Environmental Overview in Support of Petition for Changed Conditions

CPV Towantic Energy Center

October 2014

CPV Towantic, LLC

Figure 1.
Original Towantic Energy Center Layout

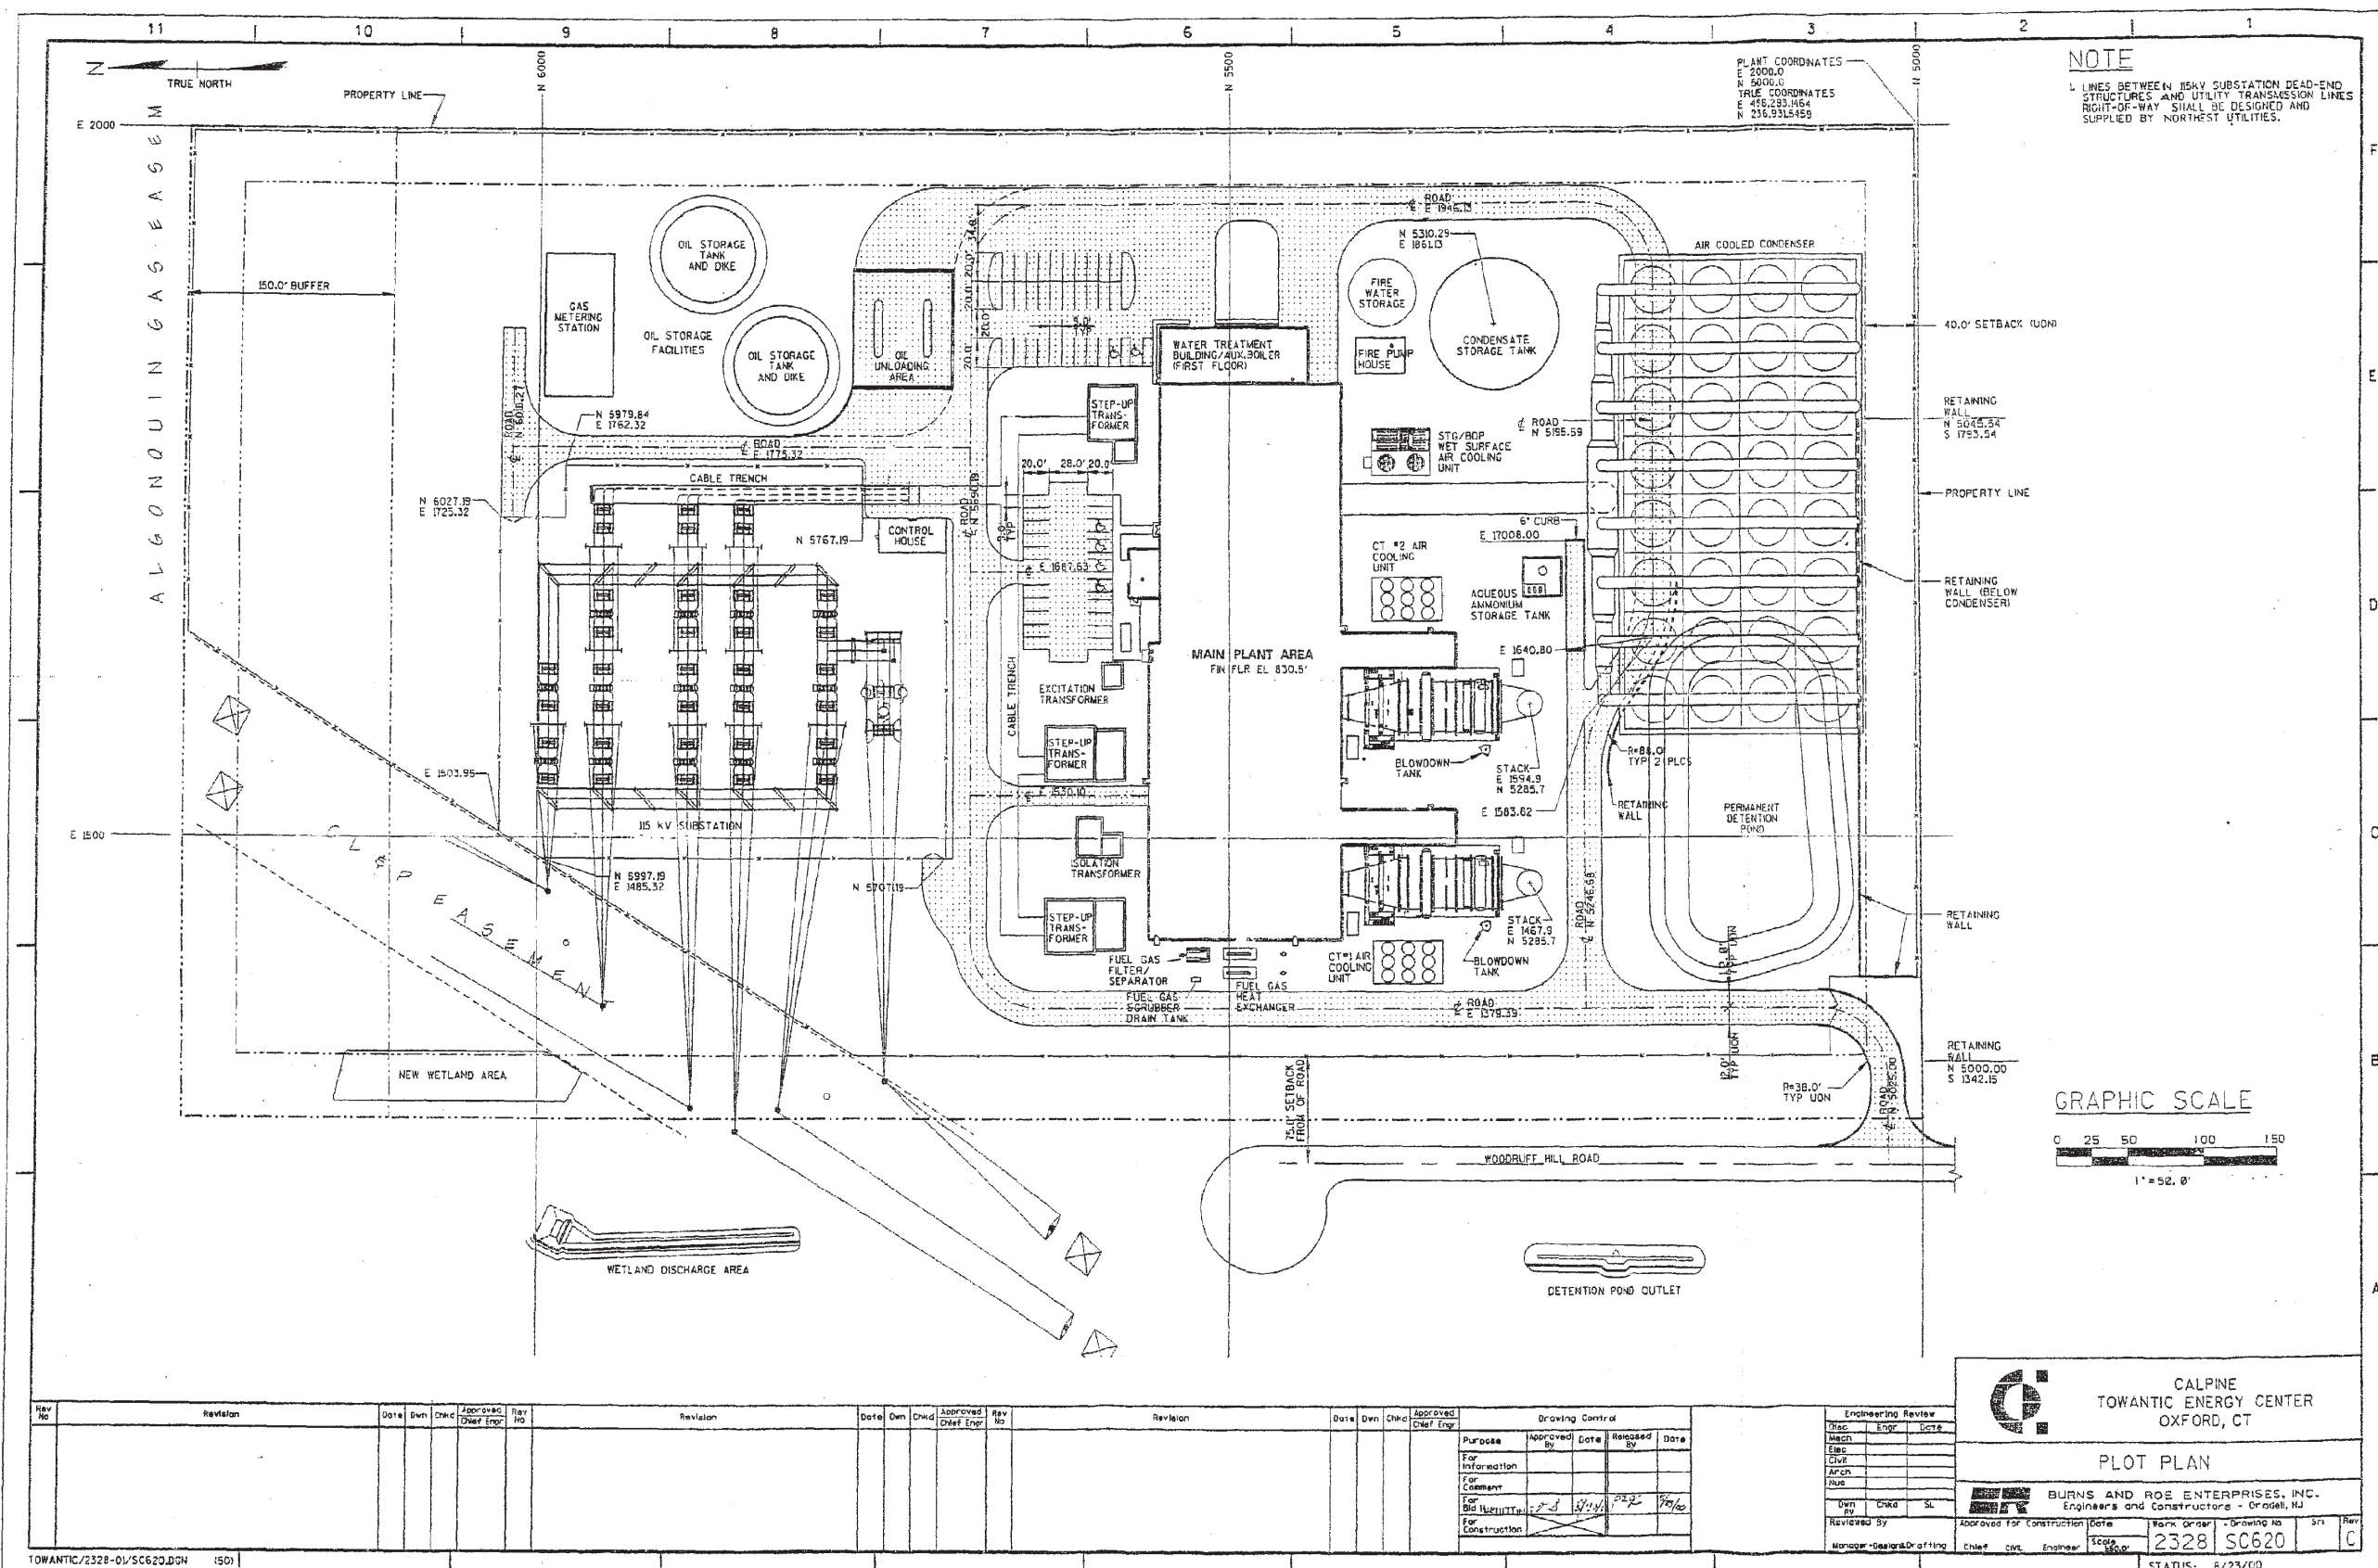
After detailed analysis, CPV determined the best approach would be to shift the stacks eastward, away from the nearby airport. The orientation and general layout of the Project remains the same, with repositioning accomplished by “flipping” the locations of the combustion turbines and the steam turbine (as shown in Figure 2). The movement of the stacks will avoid lateral navigation obstruction. The adjusted locations of the stacks has been submitted to the Federal Aviation Administration (FAA) for analysis and determination.

Figure 2.
Revised CPV Towantic Energy Center Layout

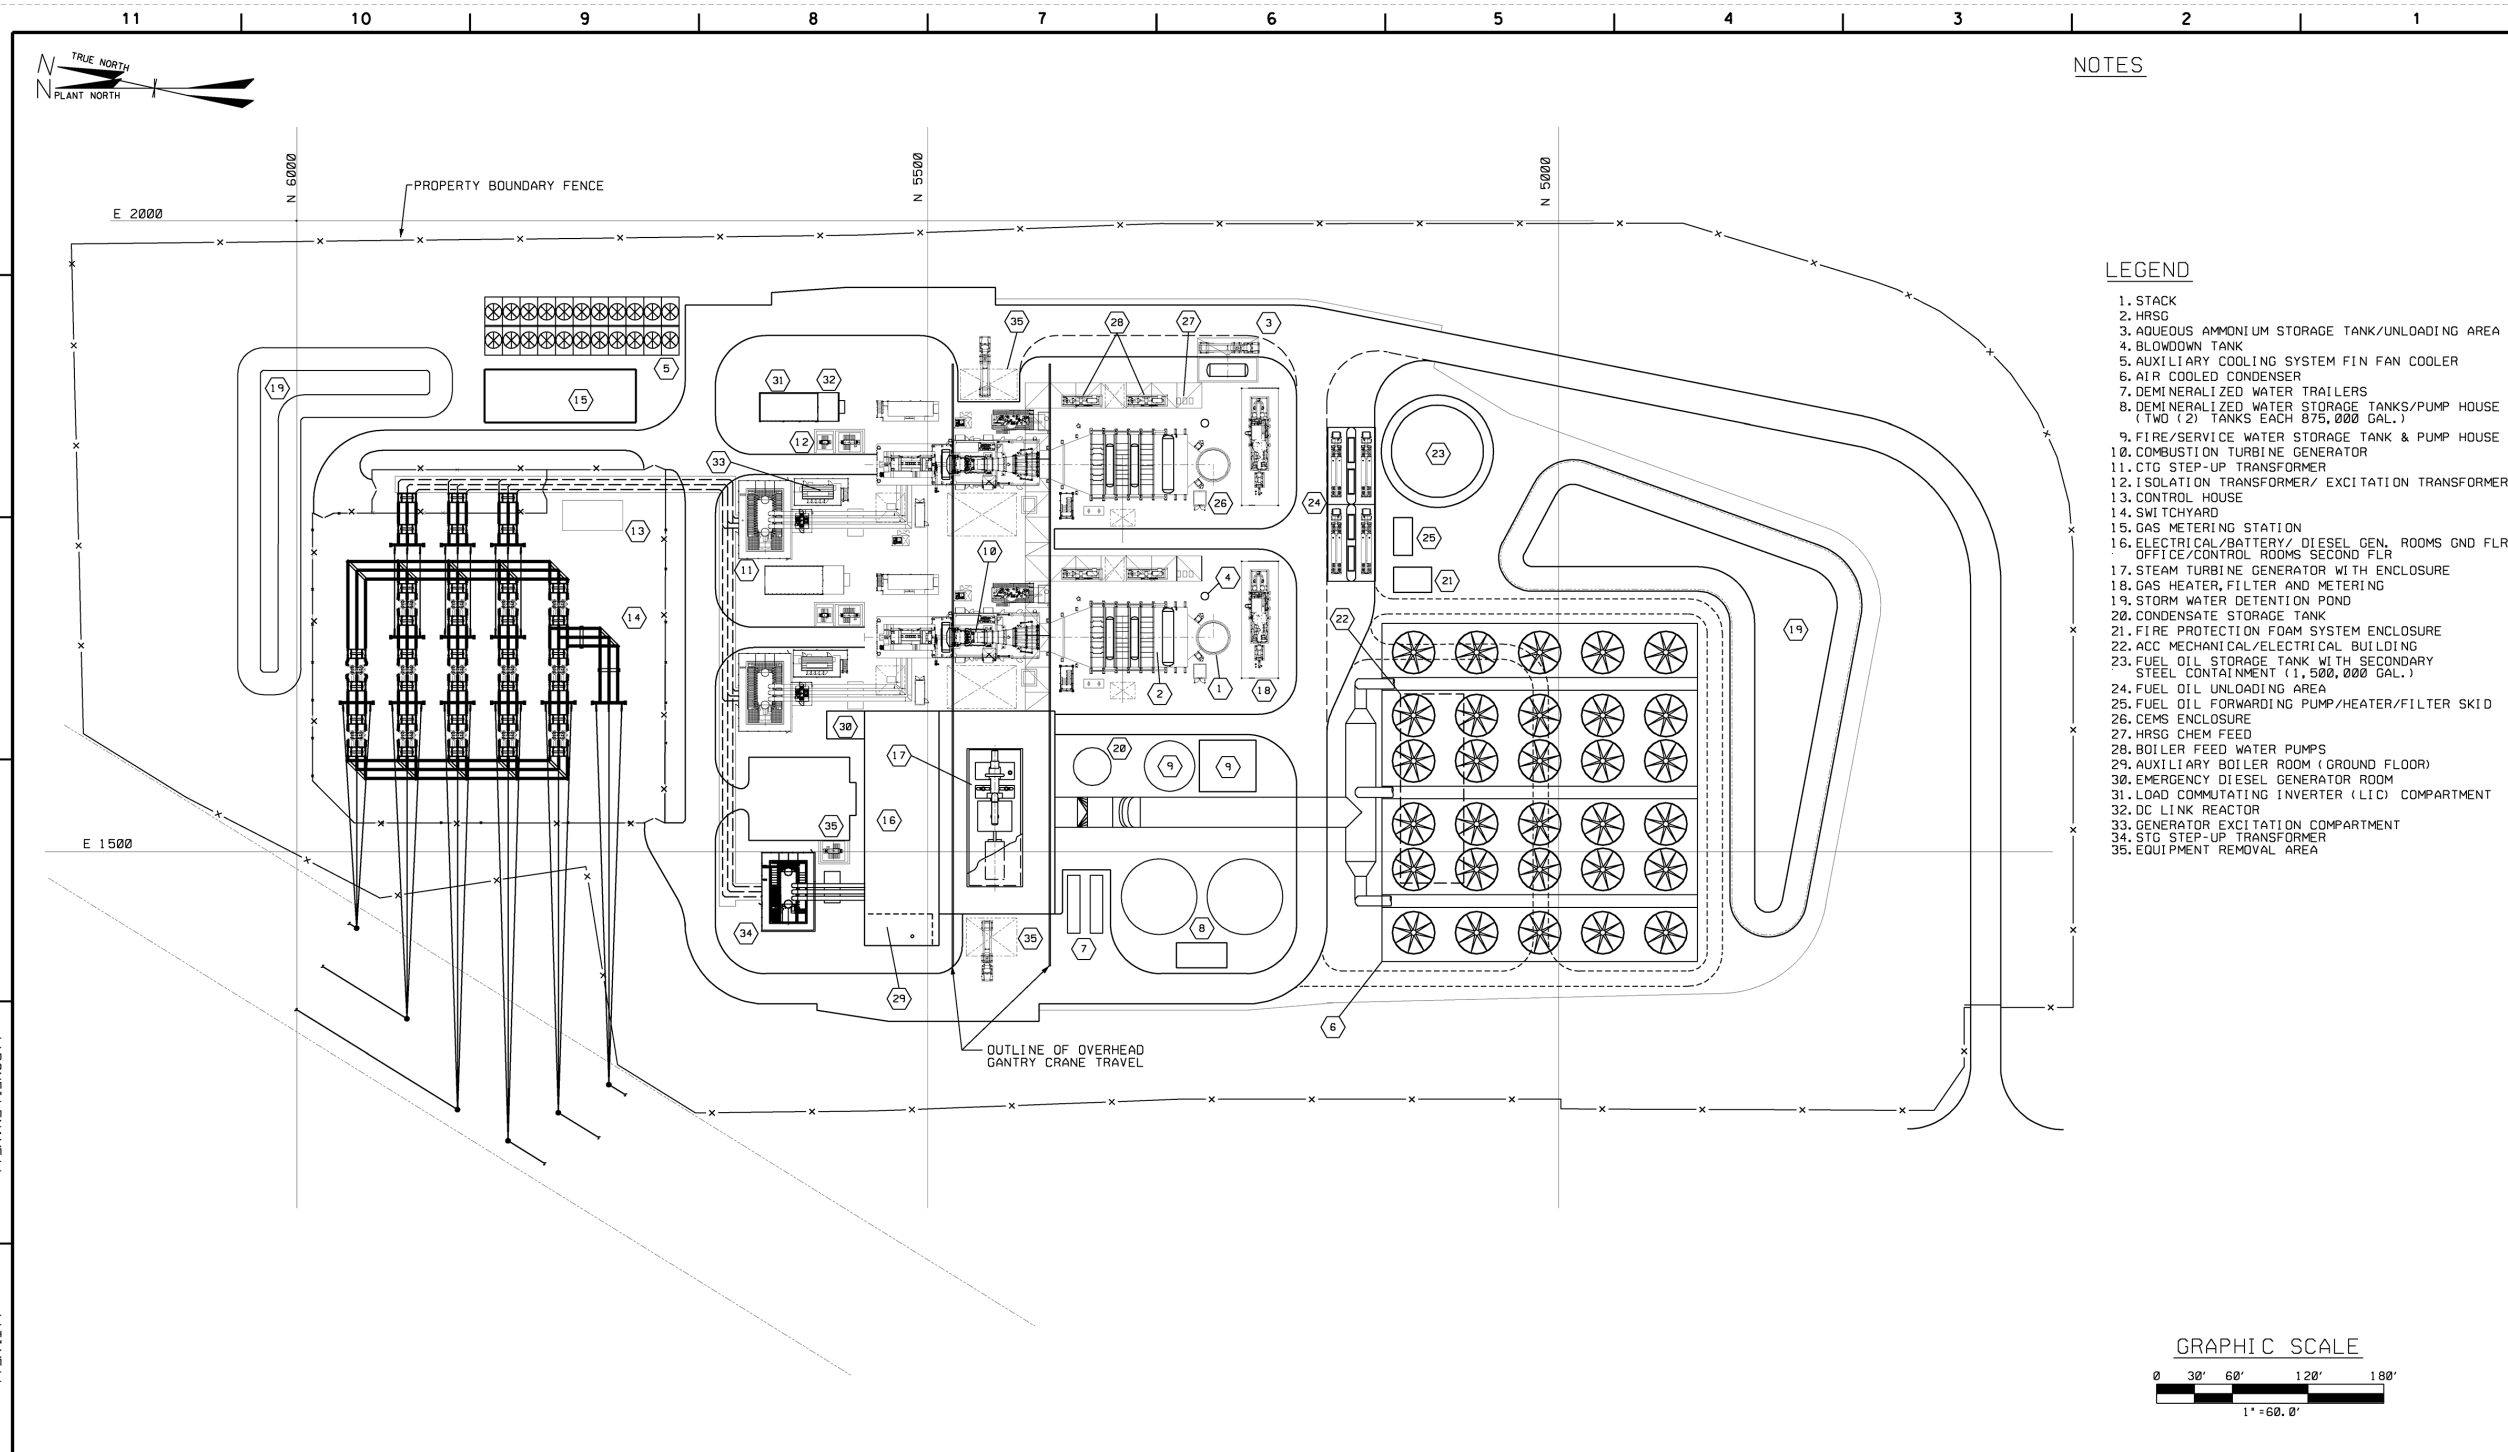
As these layout adjustments were made, engineering consideration was given to additional features of the design that could be optimized. As noted above, one such change was adjustment of the stormwater management features, to shift detention areas from under the ACC (which was not recommended by the ACC vendor) to two locations to better reflect existing site drainage patterns. One area where a retaining wall was previously proposed will now be graded. The placement and sizing of the water and ULSD tanks have been revisited, with placement now adjusted to reflect a more efficient work arrangement and use of real estate. As previously noted, one larger oil tank is replacing the two oil tanks formerly proposed, and two water tanks where one was previously proposed. The revised site layout is shown in Figure 2.
